LIST OF VALID AIP SUPPLEMENTS

AIP SUPPLEMENT

32. A.N.R. ROBINSON INTERNATIONAL AIRPORT (TTCP)

Establishment of New Taxiways, Apron and Terminal Building at the A.N.R. Robinson International Airport

Please see **Attachment A** for the updated Aerodrome Chart for A. N. R. Robinson International Airport.

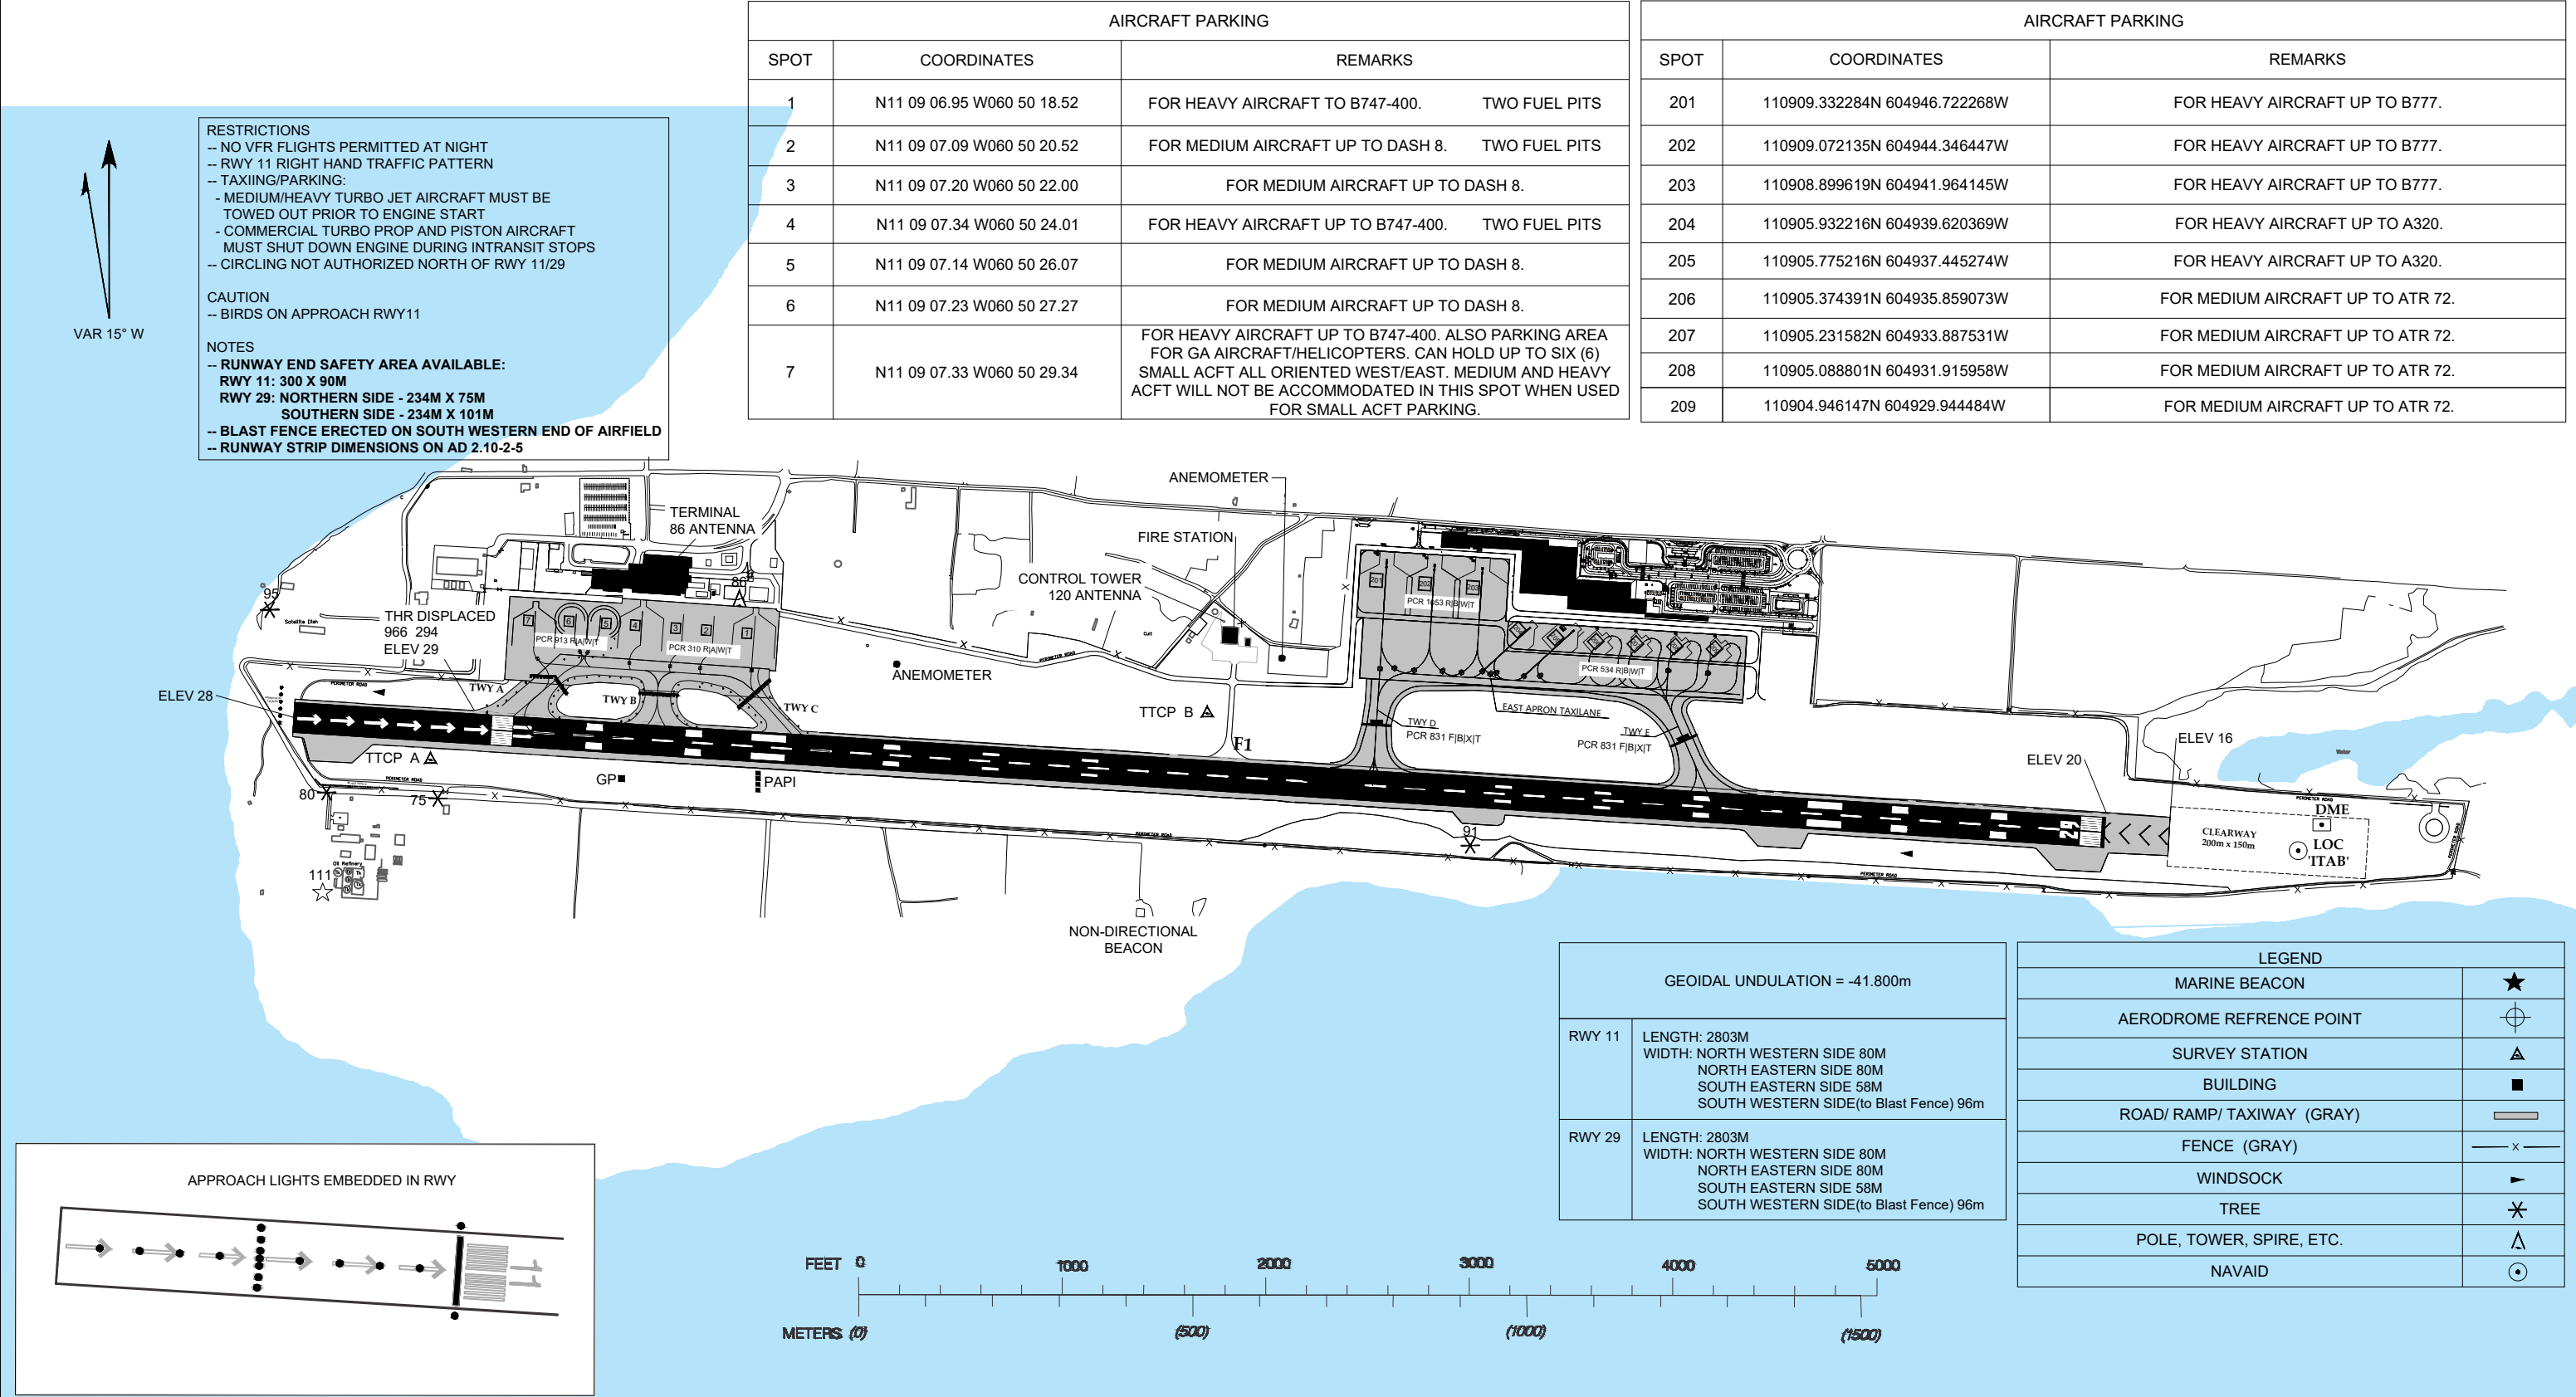
A new terminal building, apron and two (2) taxiways have been established at the A. N. R. Robinson International Airport. Seven (7) new parking positions are now available at the new terminal.

Taxiing route offering the most efficiency will be utilised from the East Terminal to depart RWY 11.

Departing aircraft may be instructed to vacate the RWY at TWY C and hold at TWY A, pending take-off clearance from ATC.

HELIPORT
CHART - ICAO

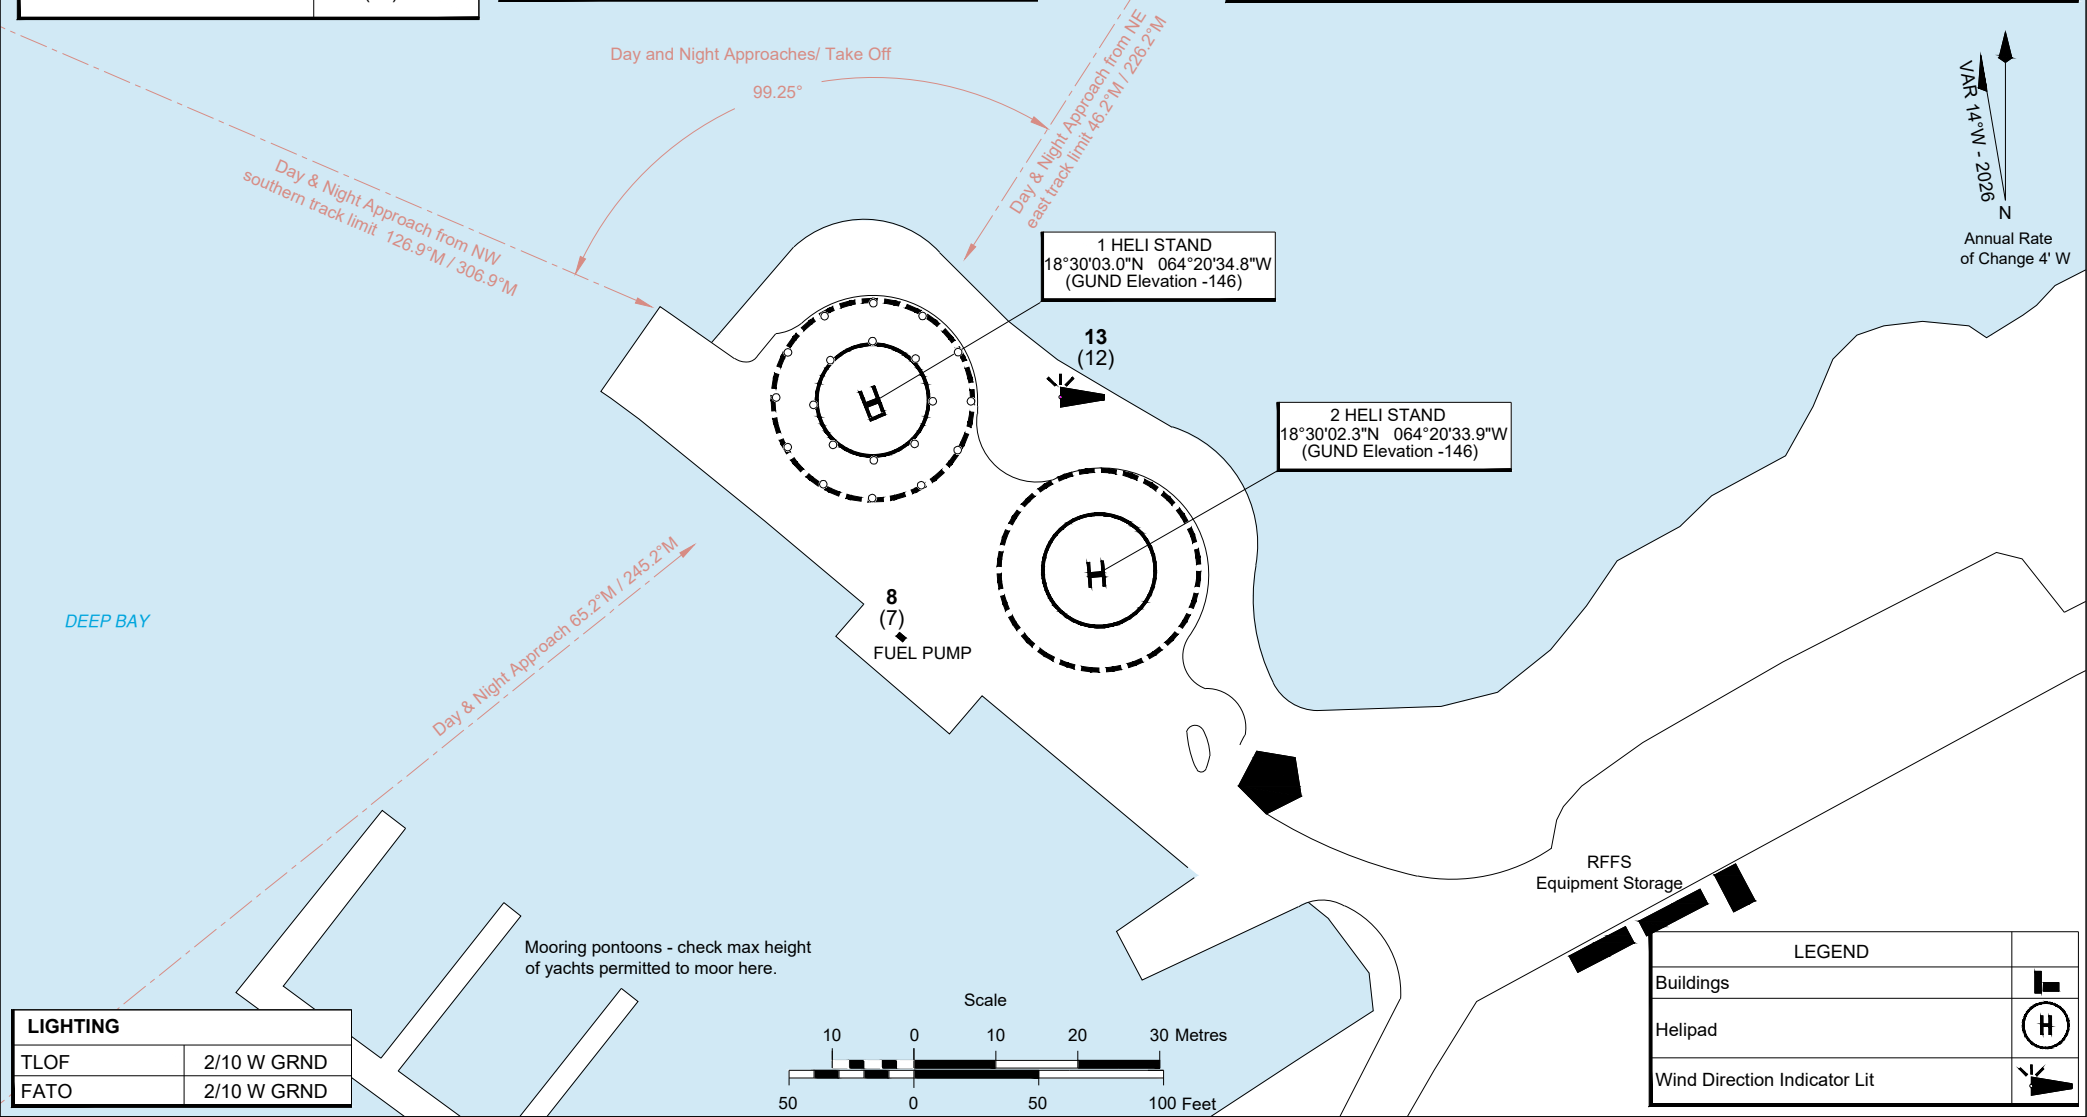
A Heliport Chart – ICAO and a VFR Chart – ICAO have been established for Oil Nut Bay Heliport.

Please be advised that these charts replace the diagrams that are published in the Eastern Caribbean AIP pages AD 3.1-7 and AD 3.1-8.

Establishment of VFR Chart – ICAO

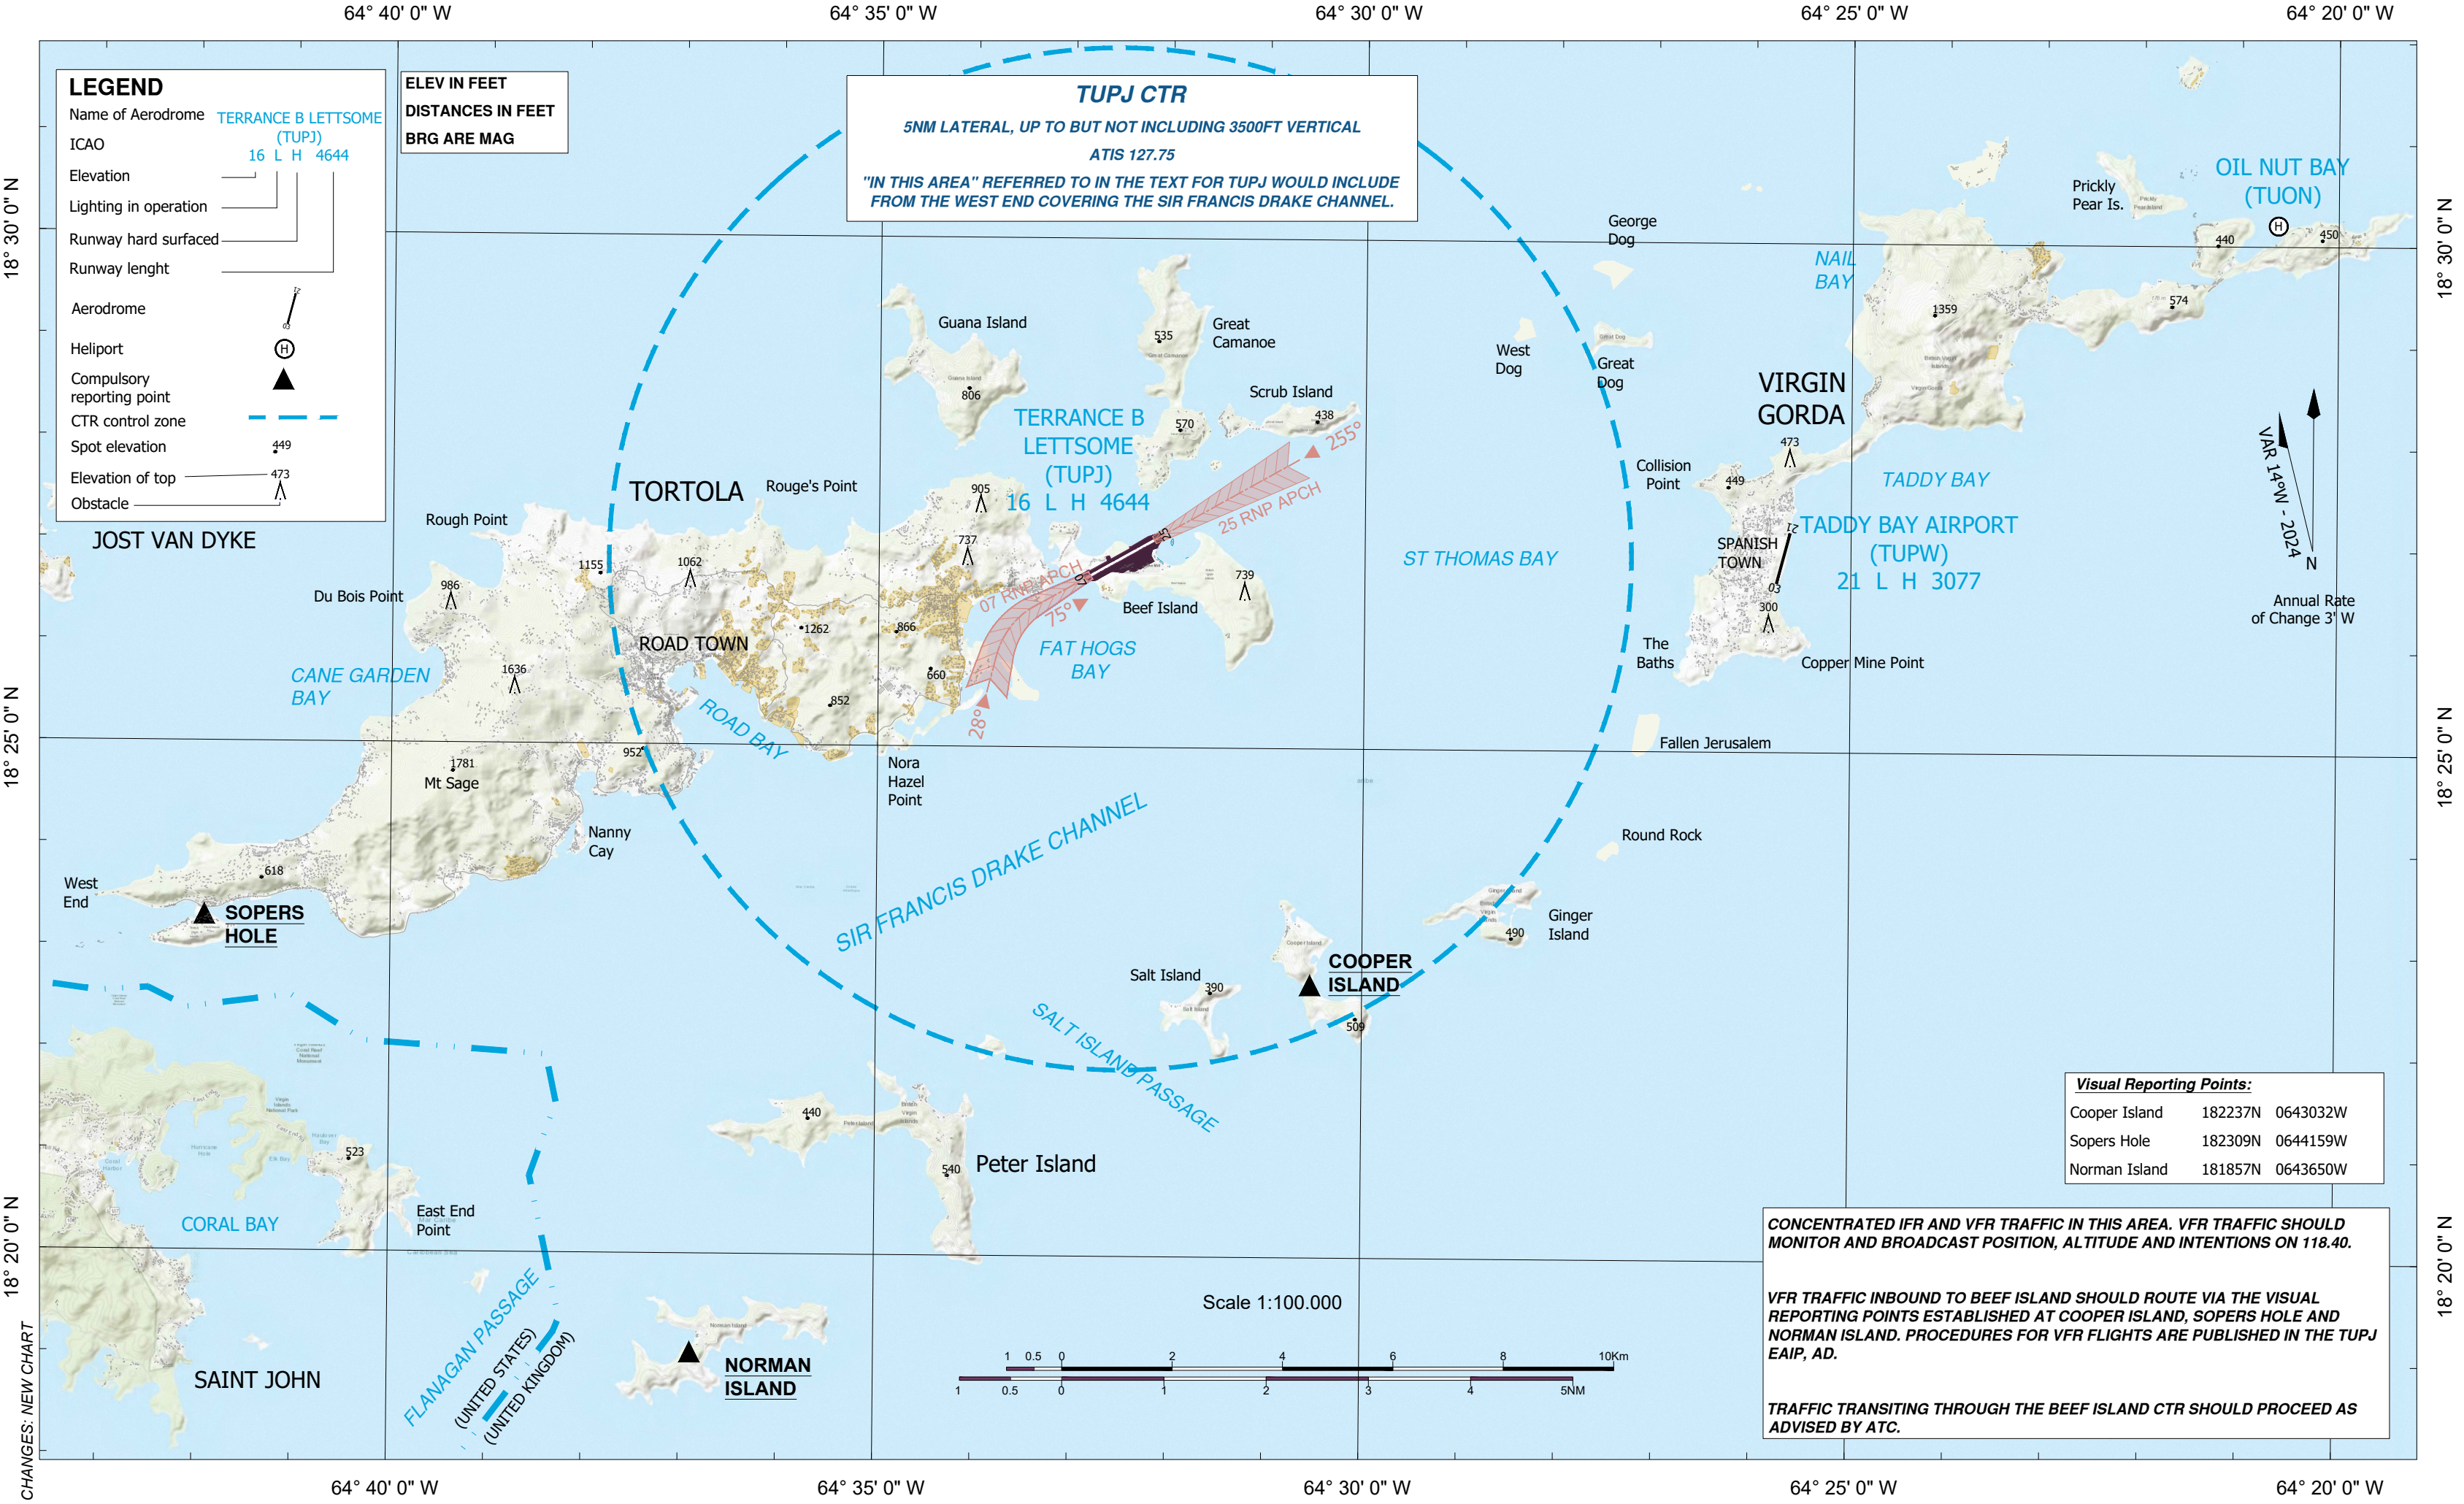
A VFR chart- ICAO has been established for Terrance B. Lettsome International Airport.
Please see Attachment A for the new chart.
